**HIGHLAND REDEVELOPMENT COMMISSION
DISCUSSION TOPICS for STUDY SESSION – DRAFT**

Review of Highland, Indiana Municipal Code Supplement

Section 214.180: RD – Redevelopment District

Review by: Chester, Inc.

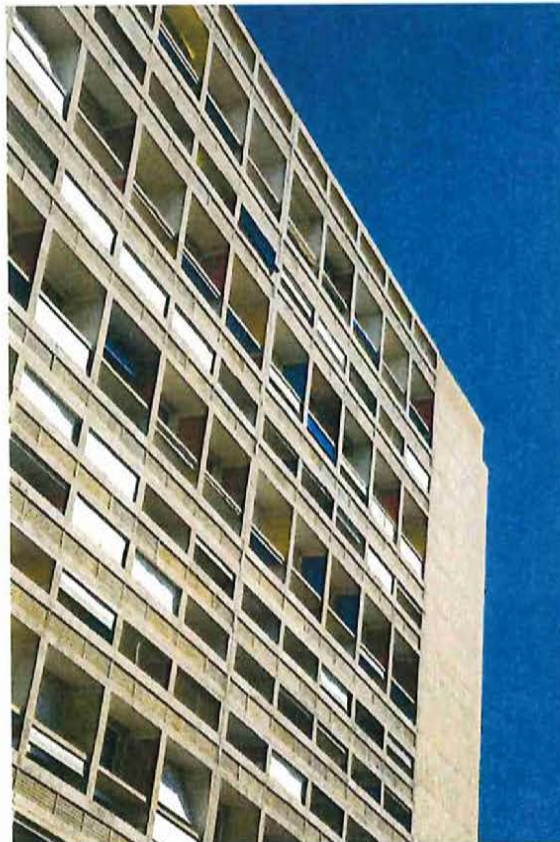
214.180.093(F)/

214.180.103(F)

Awnings can be attractively constructed of metal, woven HDPE or PVC, etc. The phrasing here does not clearly permit this.

(B) Prohibited Roof Types:

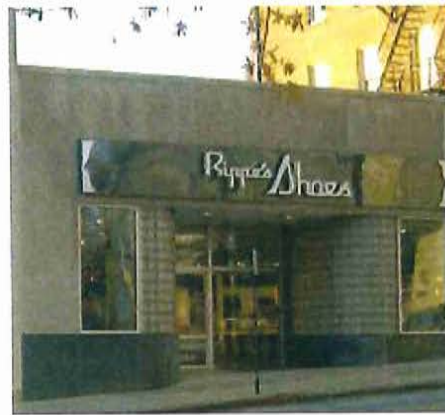
214.180.096(B)(1-2)

Shed roofs and barrel-vaulted roofs (especially where the barrel-vault is segmental, parabolic, or repeated) are common on Mid-Century Modern

buildings. Should they be prohibited under the Mid-Century Modern Design Parameters?
